RELEASE:	FINAL	TITLE:				SL-6133 Transmitter Schematic	
TOLERANCE:	.XX: ± TOL-XX .XXX: ± TOL-XXX HOLE DIA.: ± TOL-DIA ANGLE: ± TOL-ANG	Prokit Electronics Co., Ltd.					
MATERIAL:							
FINISH:		DRAWN: 2 Sep,92 WILSON DATE		PART NO: W-33A-TX		REV: F	
		SCALE:		PROJECTION:		PROJN	
						SHEET: 1

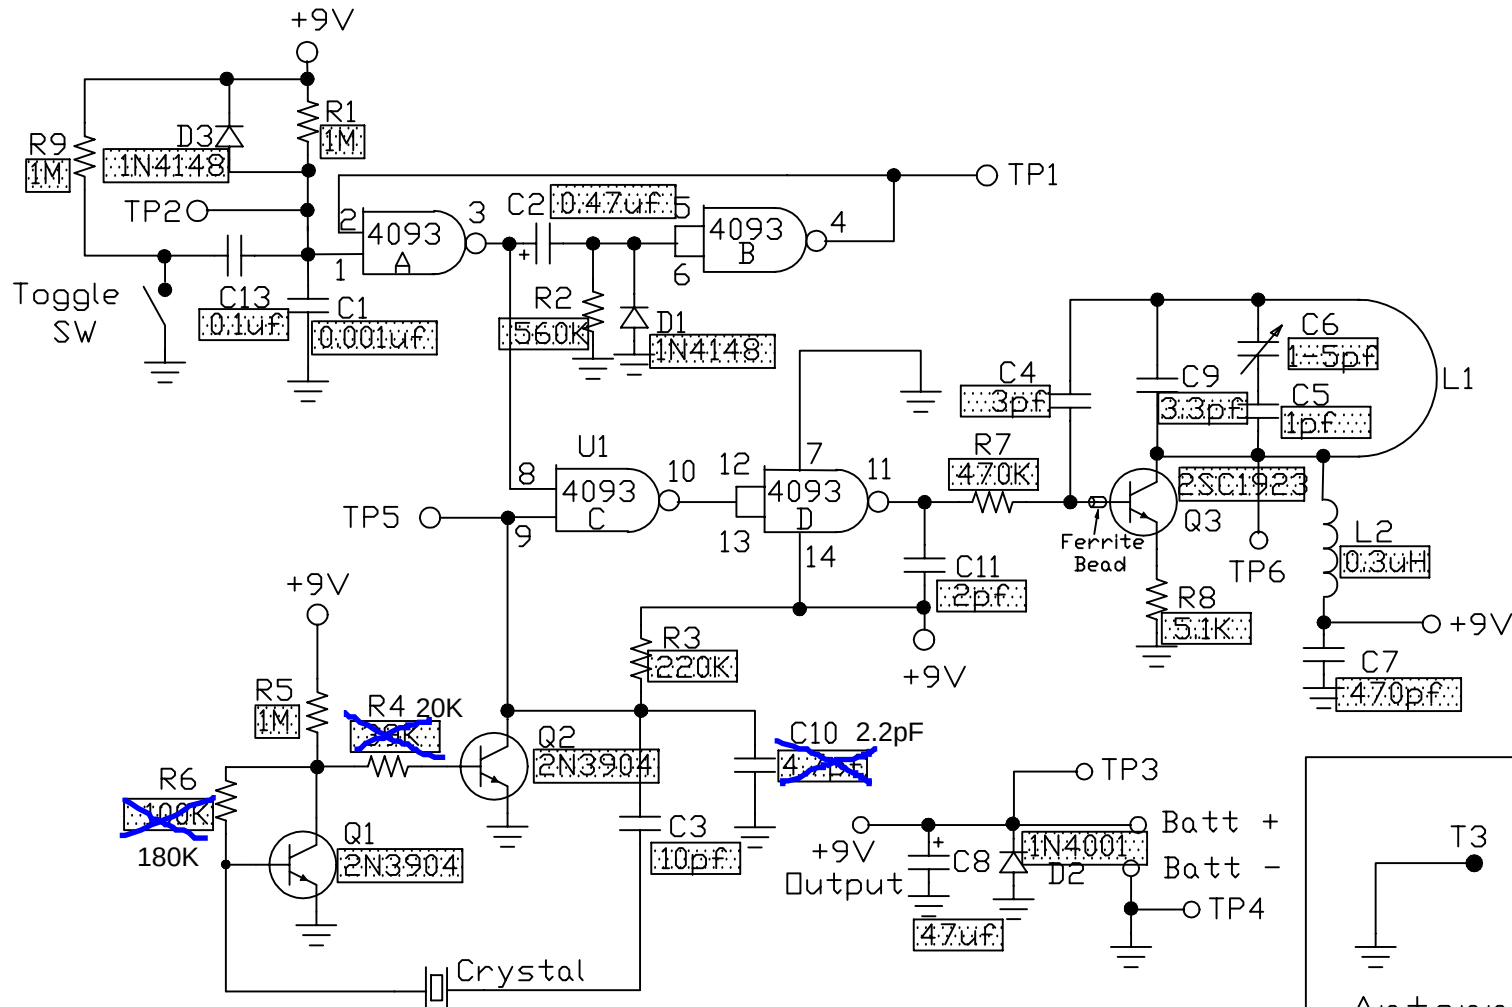
Rev:F	R8, Q3 was 3.9K, 2N5770, added a Ferrite Bead	2 Sep,92
Rev:E	R9,C13,D3 added	5 Feb,92
Rev:D	R4 was 47K	31 July,91
Rev:C	R4 was 10K, C10 added	14 May,91
Rev:B	R4 was 47K, C10 removed	1 May,91
